Interactive comment on “Accounting for seasonality in a soil moisture change detection algorithm for ASAR Wide Swath time series” by J. Van doninck et al.

Received and published: 14 February 2012

Fig. 1.

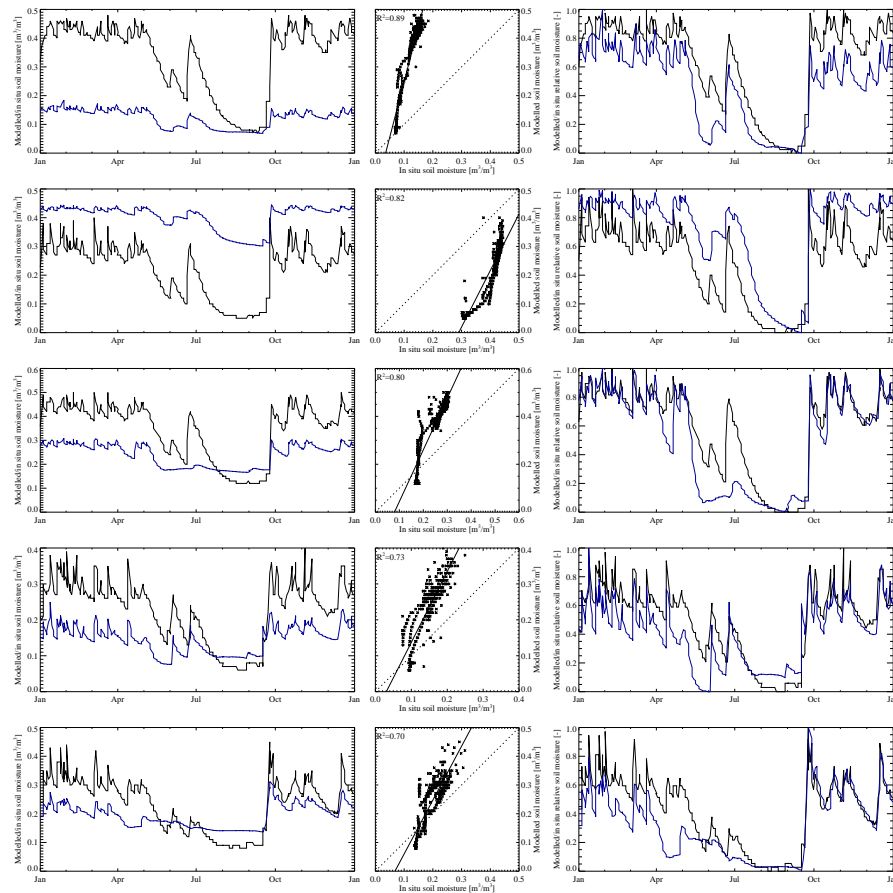
1-Validation of the hydrological model. 2-Derivation of the seasonal angular correction coefficient and discussion 3-Comparison with low resolution soil moisture products

1-Data of the five in situ stations in Calabria have been incorporated in the revised manuscript. To this end, the hydrological model was run over a depth of 30 cm. Comparison of modelled and in situ soil moisture at 30 cm (Fig. 1) shows that the model strongly overestimates the dynamic range of soil moisture, which is mainly because the model provides an average over the 30 cm top layer, while in situ measurements provide soil moisture at a depth of 30 cm without integrating soil moisture of the layer above. There should however be no problem in using the modelled soil moisture as validation for remotely sensed soil moisture, since modelled soil moisture is strongly correlated to in situ soil moisture and modelled soil moisture is rescaled between 0 and 1, as is ASAR soil moisture.
